POWERHOUSE ULTIMO REVITALISATION

Public Domain
& Landscape
Statement

RTS

1.3 The Terrace plan showing areas of hardscape and key path widths

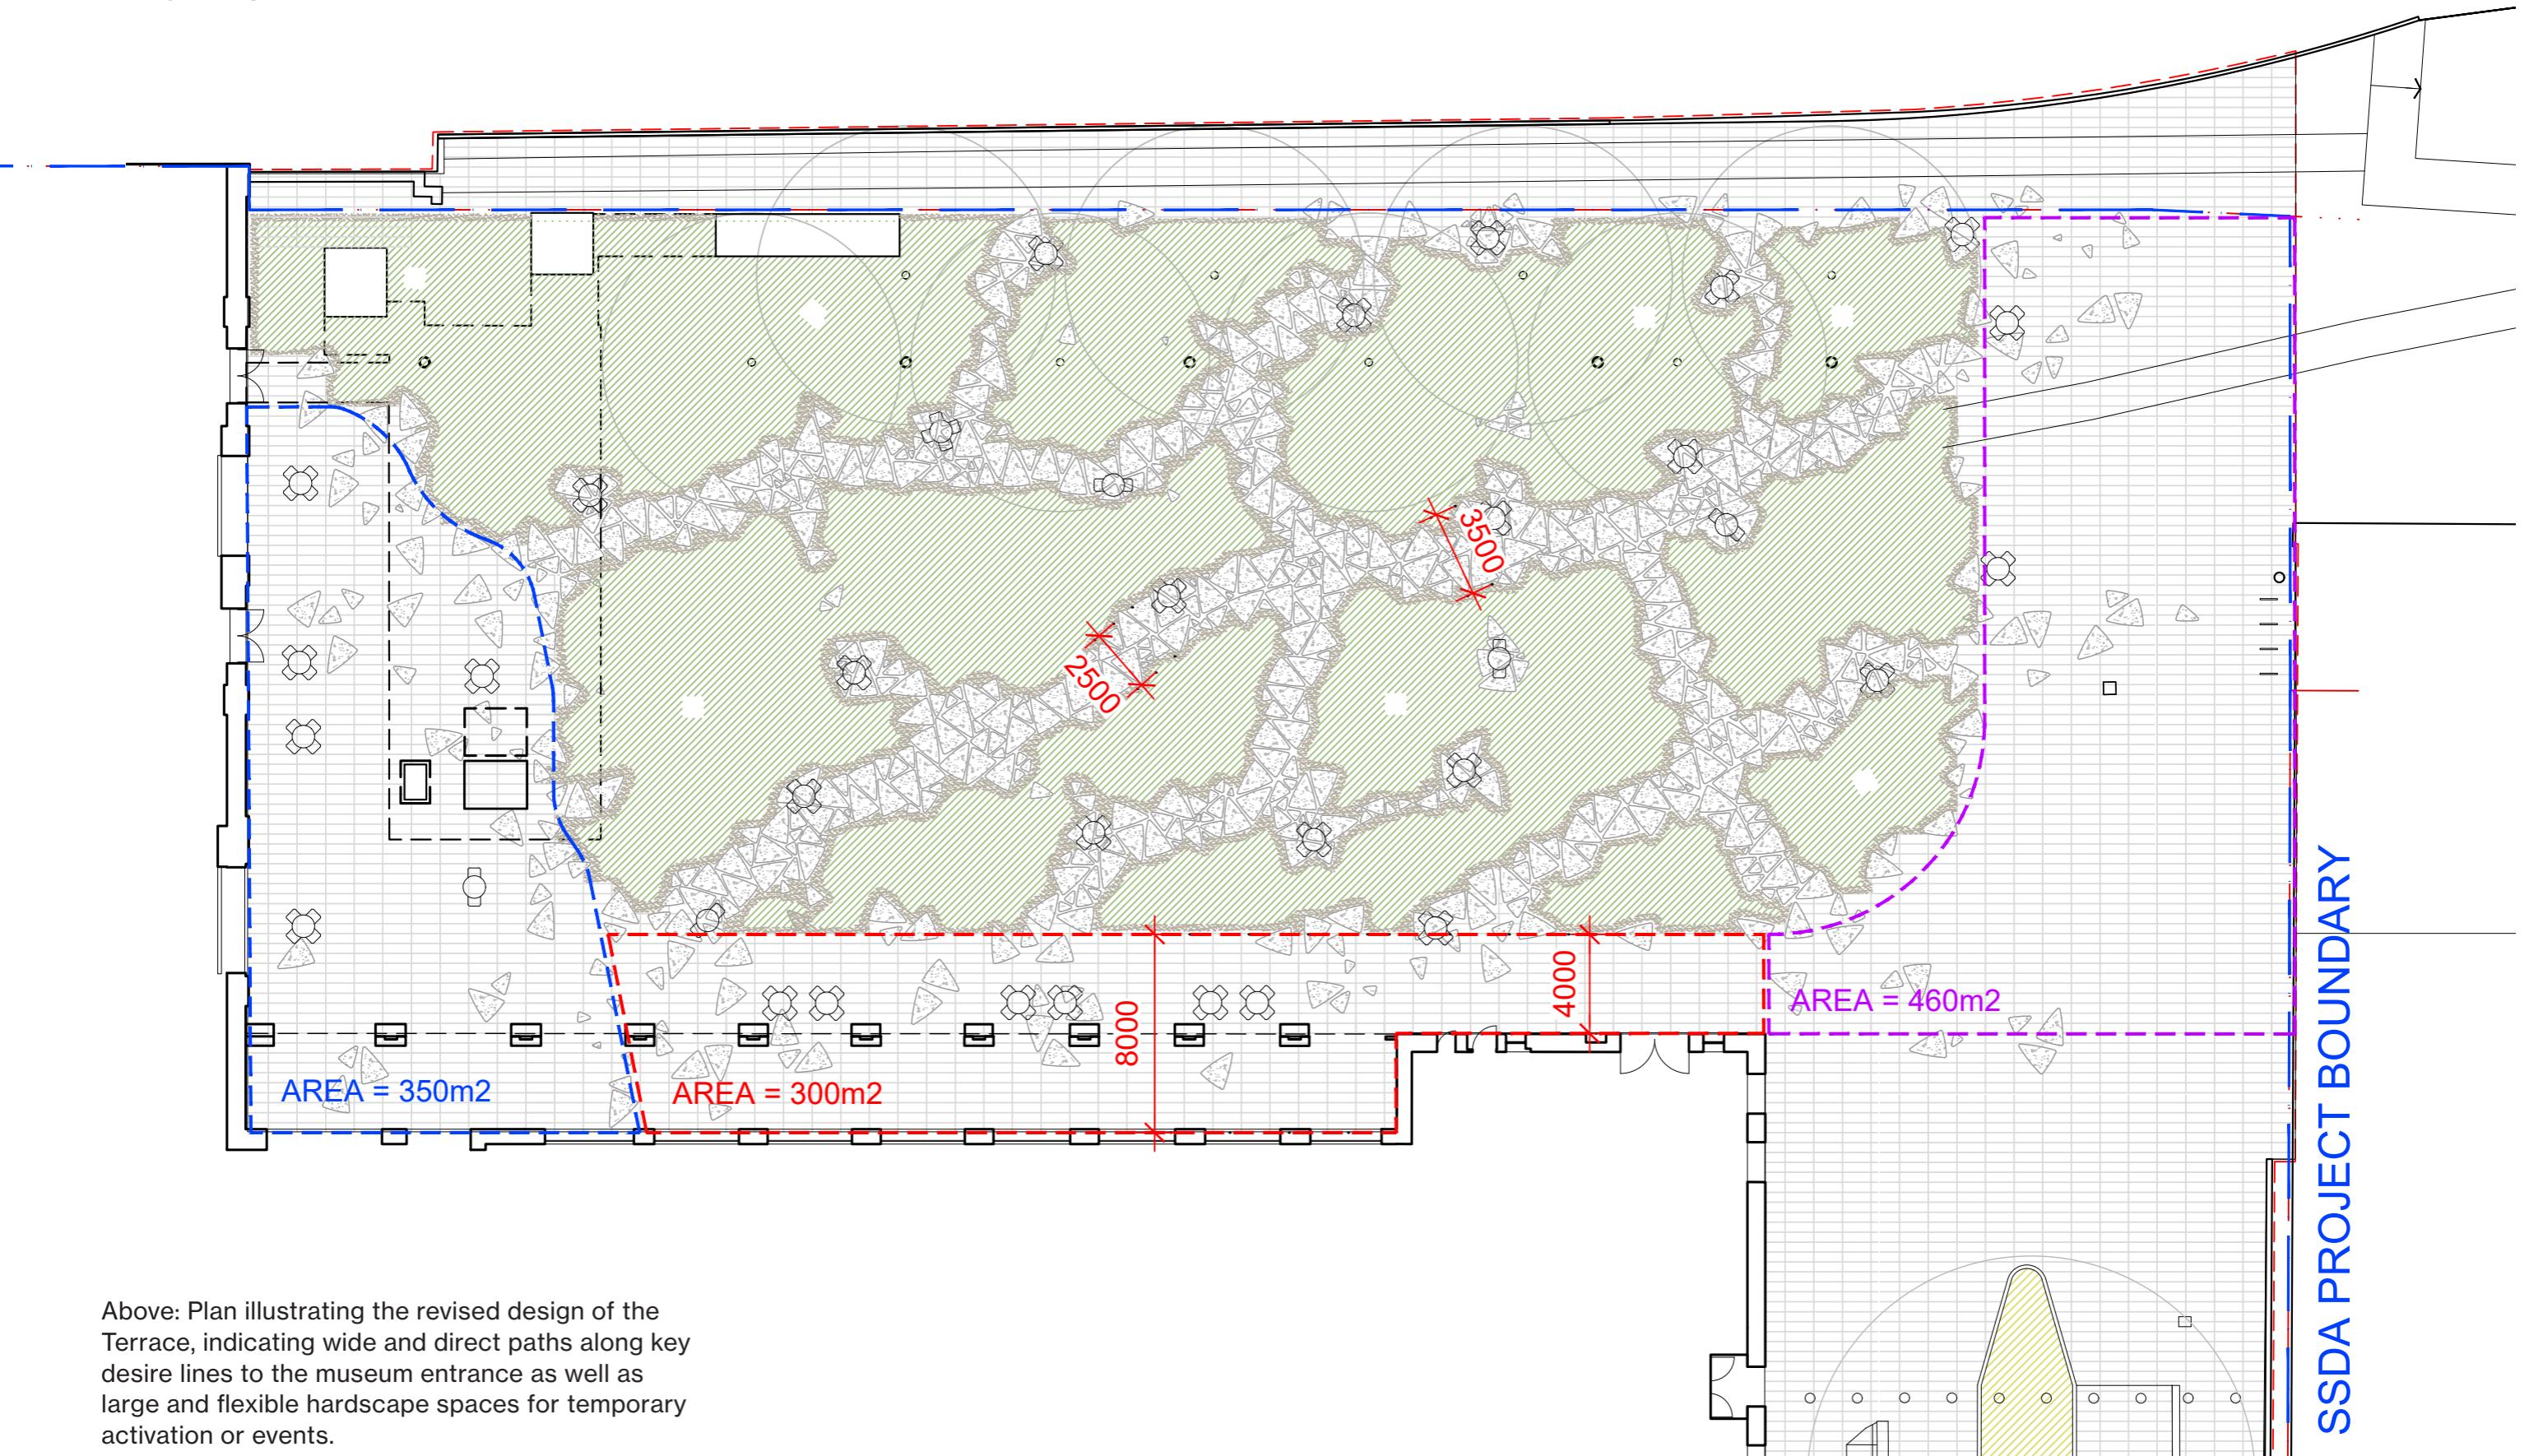
- A new 4m wide path has been provided along the switch house edge, ensuring there is a very wide, clear public path to the new front door. Beneath the colonnade, this path widens to 8m, allowing clear pedestrian access but also significant spill out space for café seating and activation of the Switch House adjoining the Terrace. These dimensions are provided on the plan on the following page.

- The paths through the landscape have been redesigned to allow a greater width. The main diagonal desire line from the Goods line to the museum entrance has been widened to between 2.5m and 3.5m width. These dimensions are provided on the plan on the following page.

- The revised design includes a new hardscape area of approximately 350m² at the new front door of the Powerhouse. All the paths land in this space, allowing ample room for gathering groups of visitors at the entry or event activation throughout the year. This area is indicated on the plan on the following page.

- In addition to the 350m² hardscape space, there is another 300m² hardscape along the edge of the Switch House allowing for ample outdoor gathering space for any Powerhouse events that might spill out from the Switch House and entry foyer. This area is shown on the plan on the following page.

- In addition to these areas, there is a 460m² hardscape within the site boundary at the south of the terrace. This space is illustrated on the plan on the following page.

1.5 The Terrace plan showing swept paths

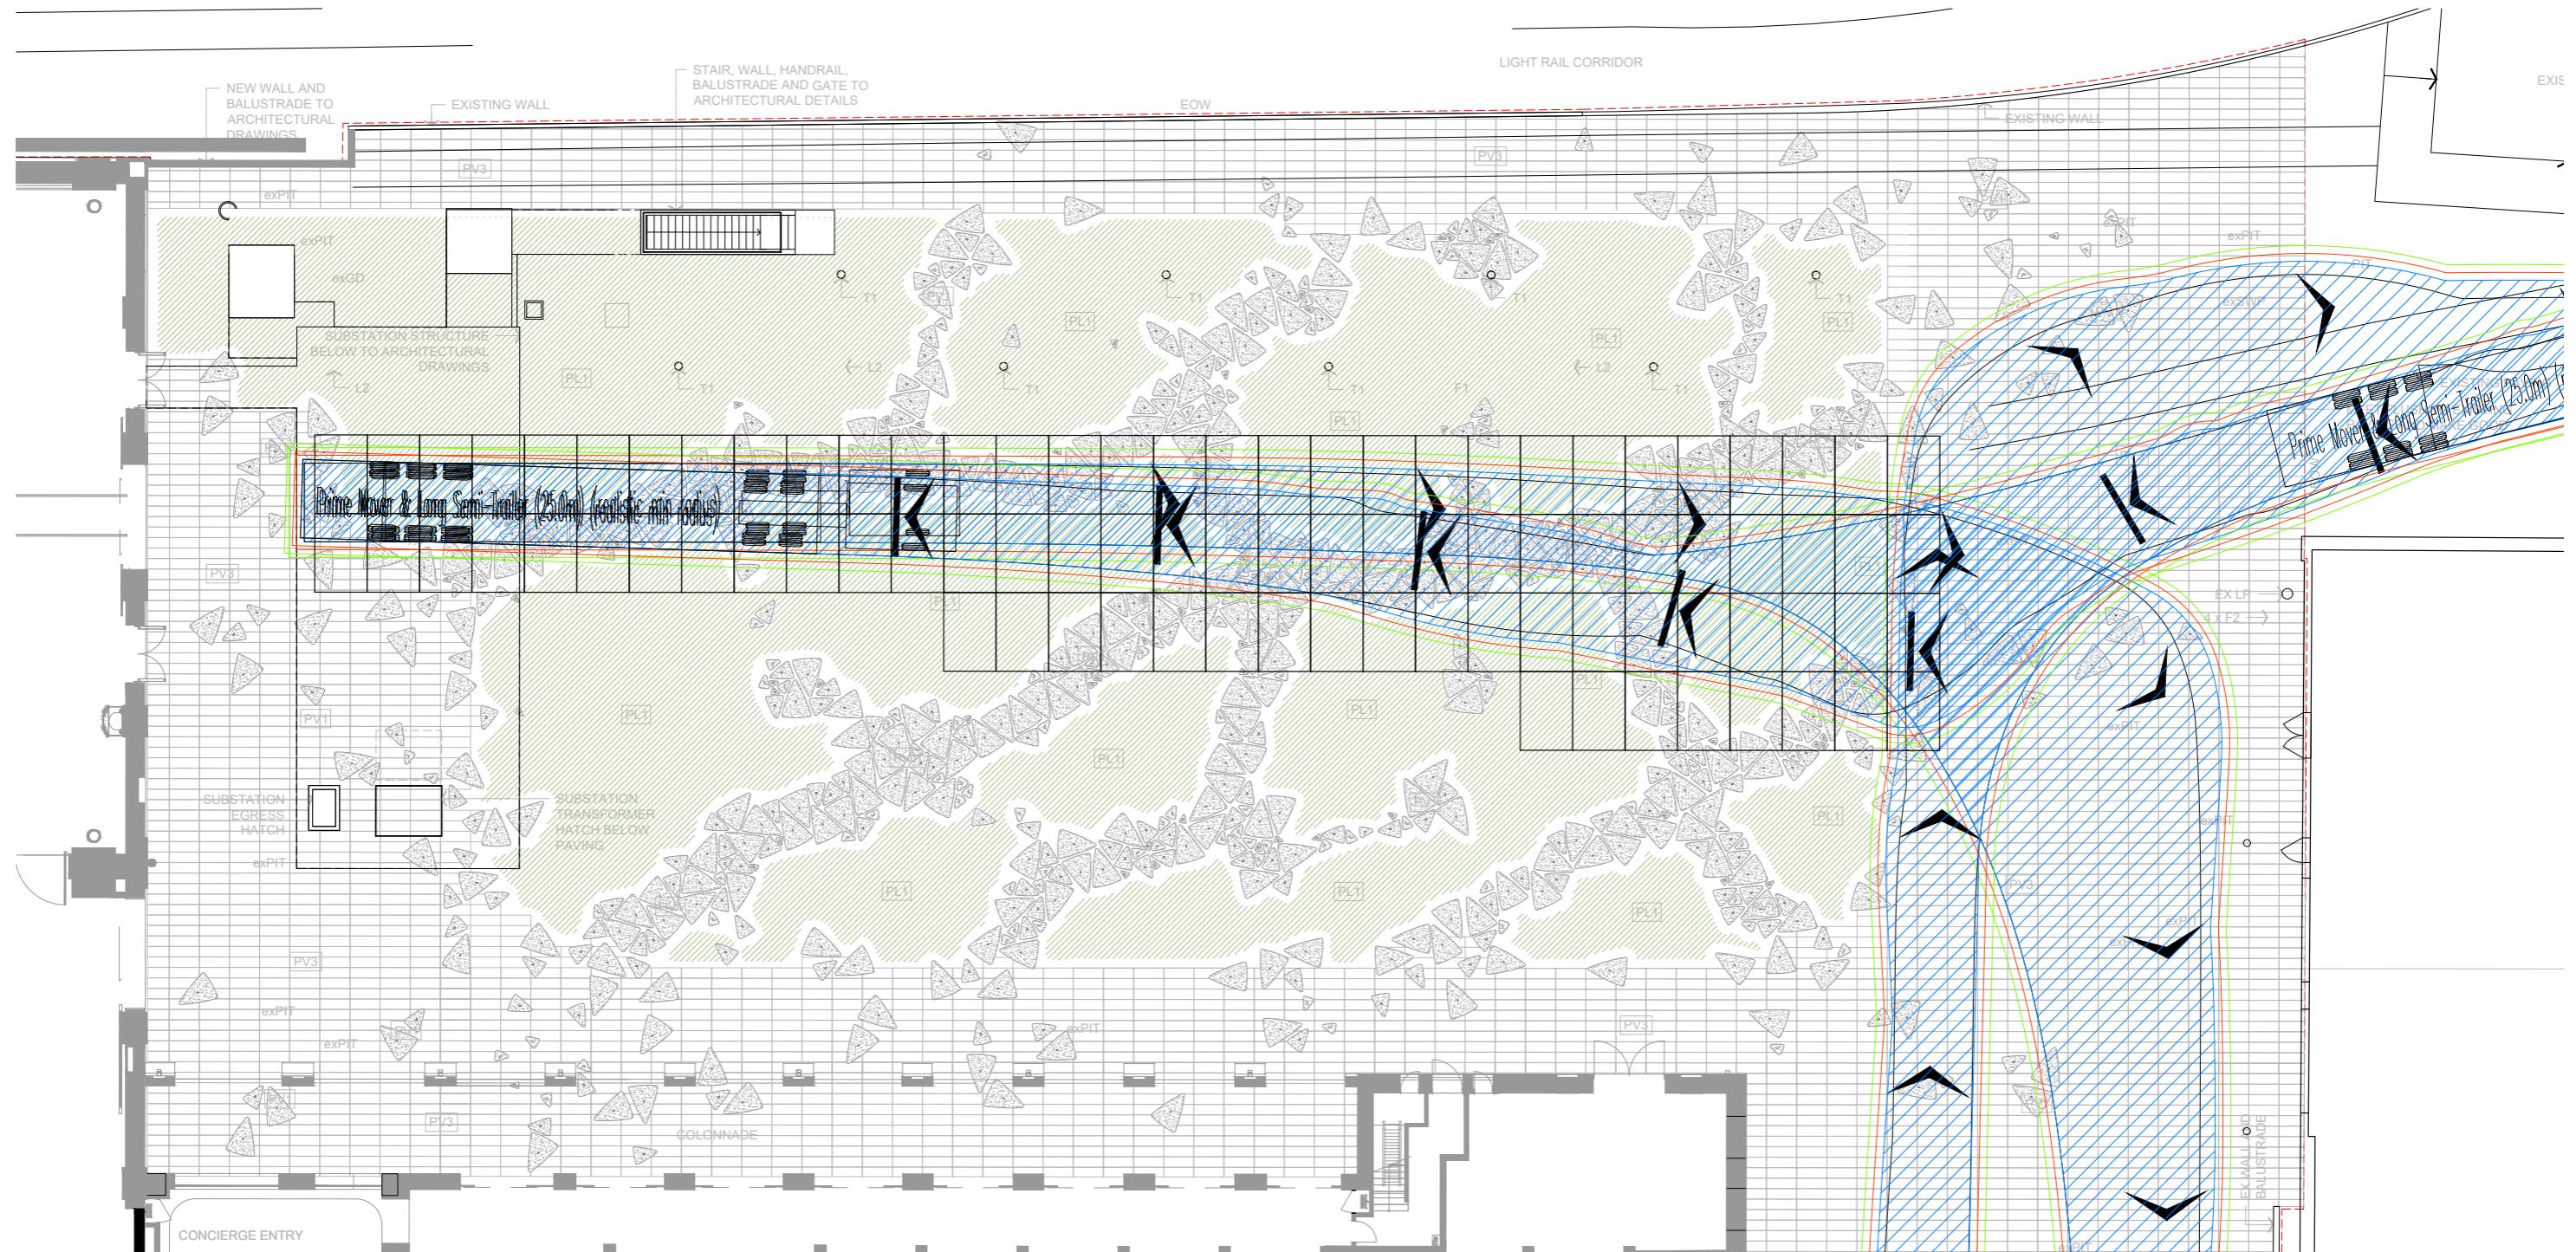
- The strategy to accommodate this loading will be to utilise a grid of Signaroad panels <https://aisfloors.com.au/product/signaroad/>
- The process for loading across the Terrace will be planned in detail as part of the major event of moving very large objects in or out of the museum. An area of grasses would be cut back to ground level, flush with the path system of the Terrace. The Signaroad panels would then be placed and bolted together as designed. This creates a singular trafficable surface.

- After loading, the panels would be removed and the areas of impacted planting would be rejuvenated or replanted.
- The path system of the Terrace has been designed to accommodate the loads required so there will be no damage.

- Rectification of the areas of landscape as required is regarded as an acceptable component of the overall logistics of very large object loading.
- The panel layout and proposed swept path alignment is illustrated in the plans on subsequent pages.

Right: Plan illustrating the revised layout of the Post Office Courtyard. Soil extents are described in the Soil section on subsequent pages.

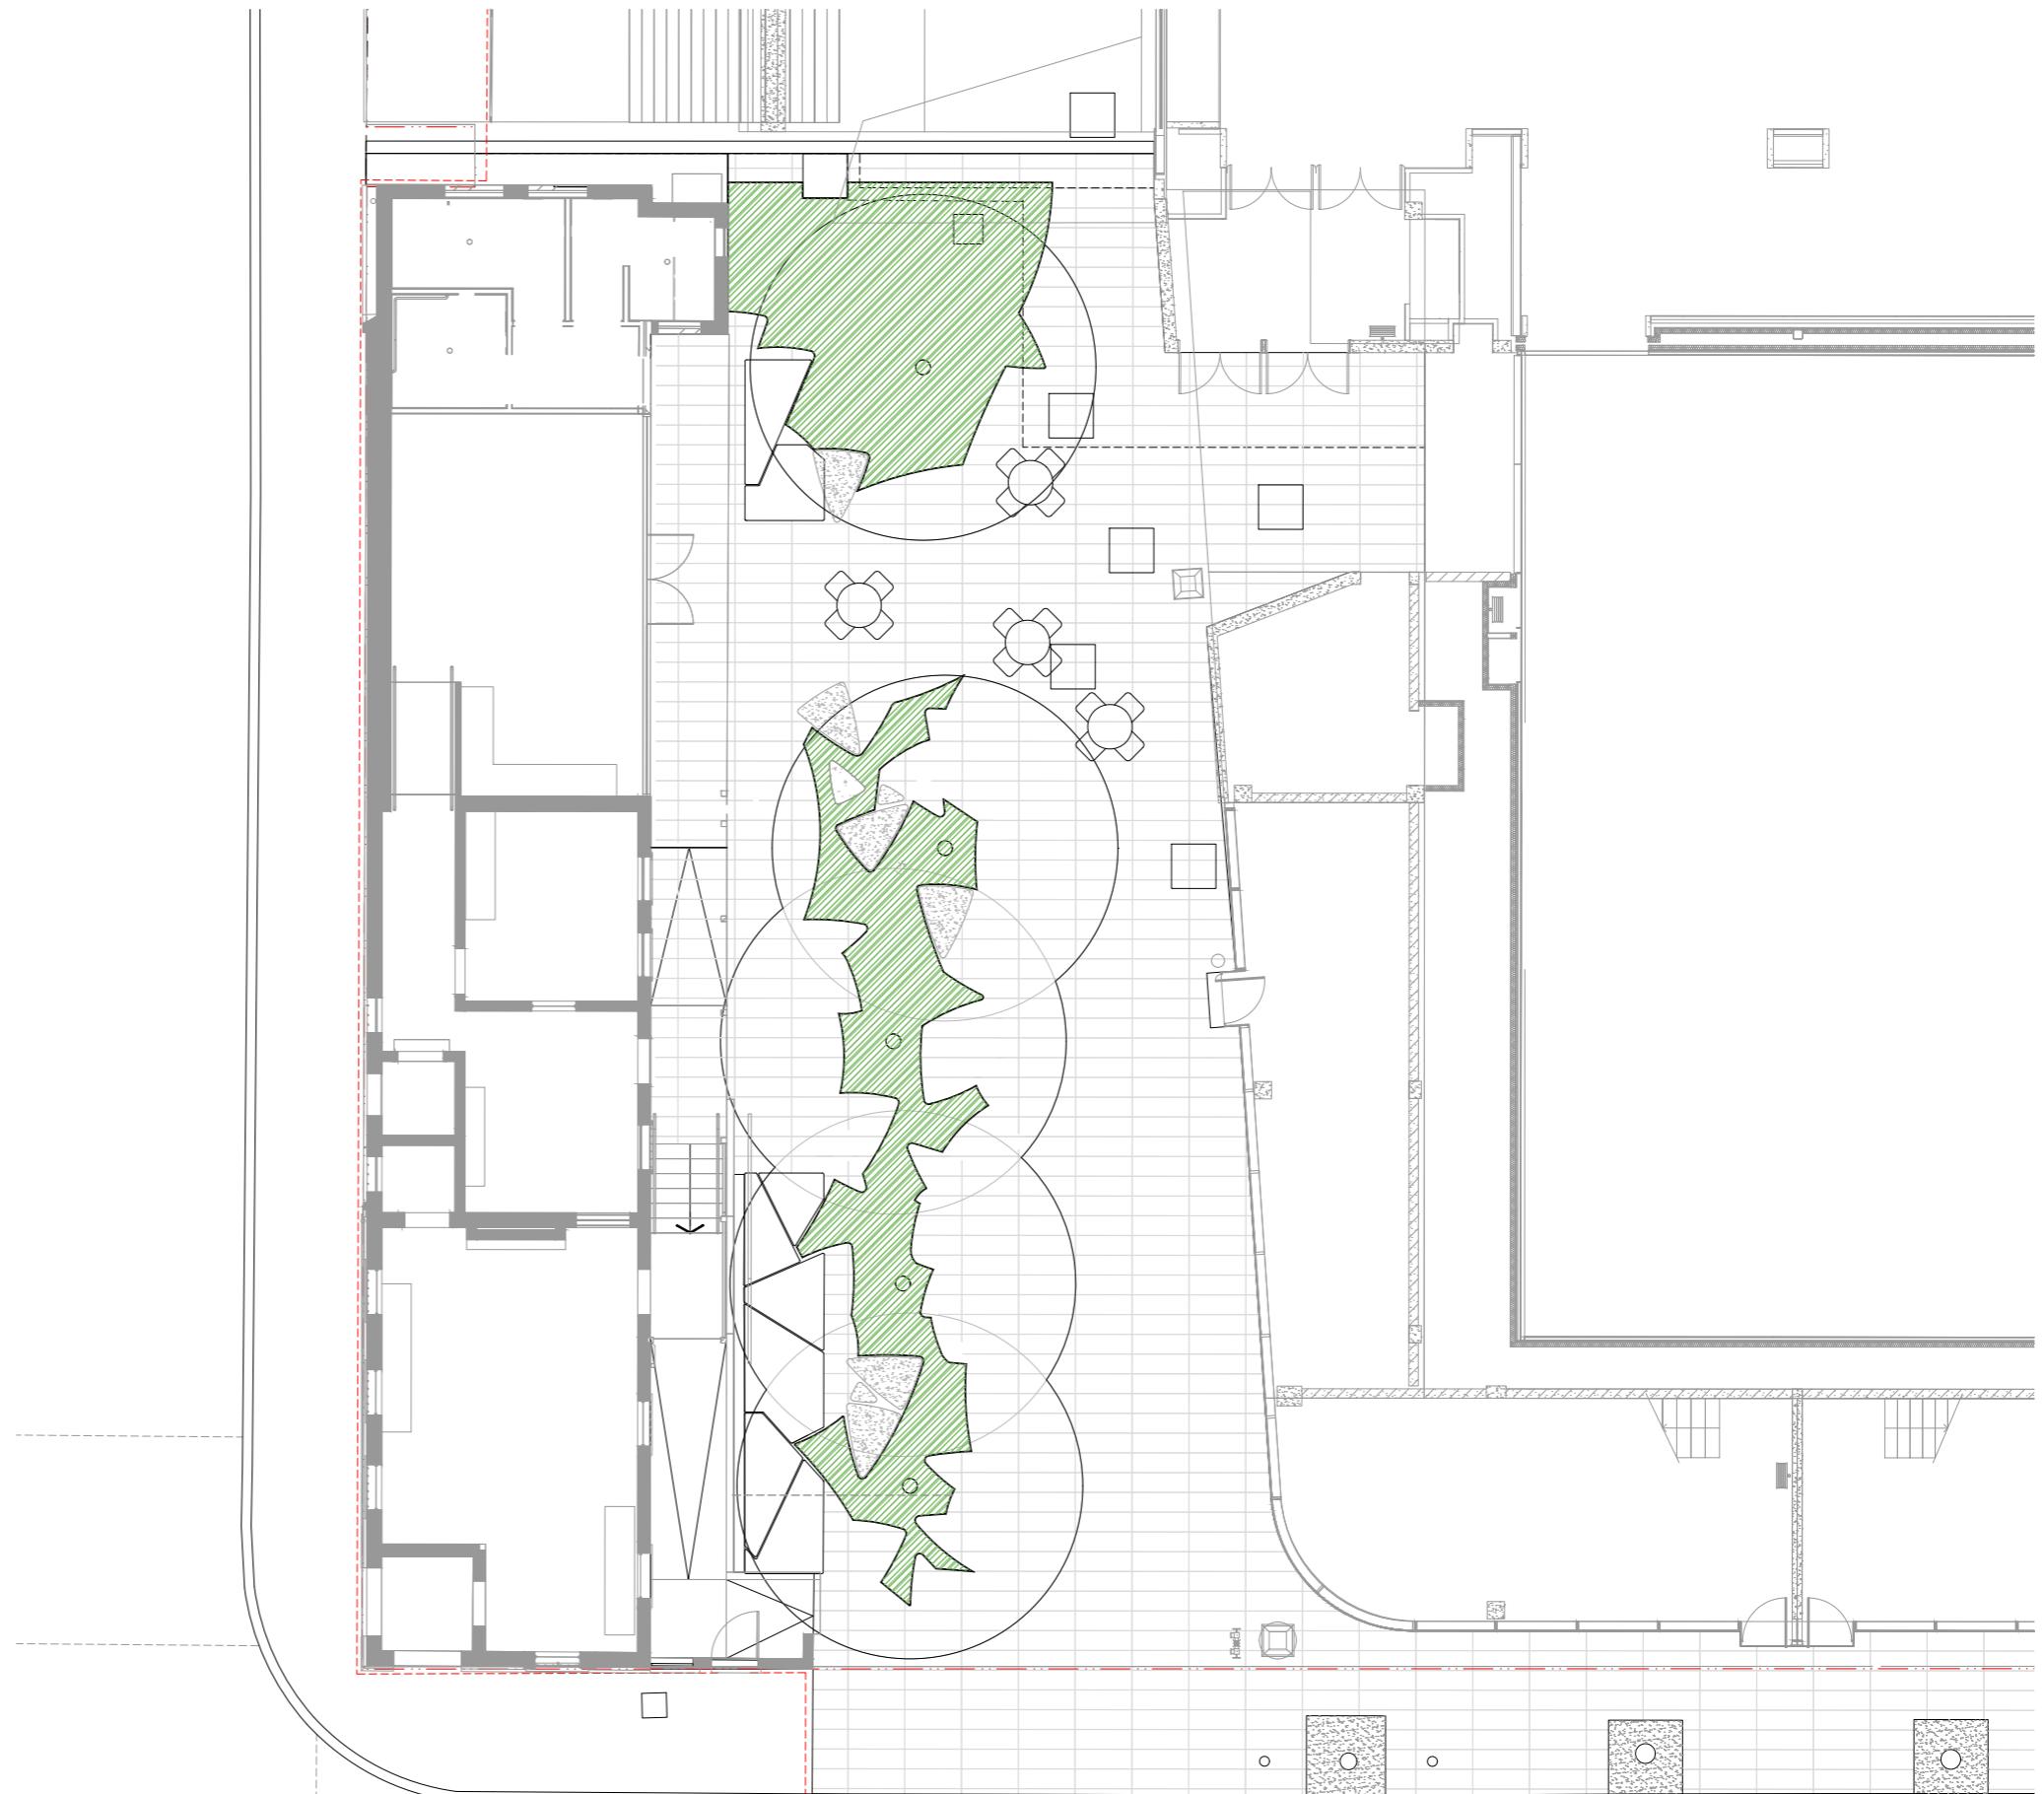
- The design of the Post Office Courtyard has been updated to include 5 x *Angophora costata* trees to replace the previous proposal of *E.racemosa*.
- The proposed trees will be planted at a 4m spacing resulting in fewer trees than the SSDA proposal. This spacing will ensure the creation of a healthy stand of sculptural trees at spacings as they are often encountered in natural settings.
- There are no tree grilles in the Post Office Courtyard, rather, the *Angophoras* are all planted in soft landscape/ planter beds.
- Details on the provision of a large connected soil volume for these trees are provided on the following pages.
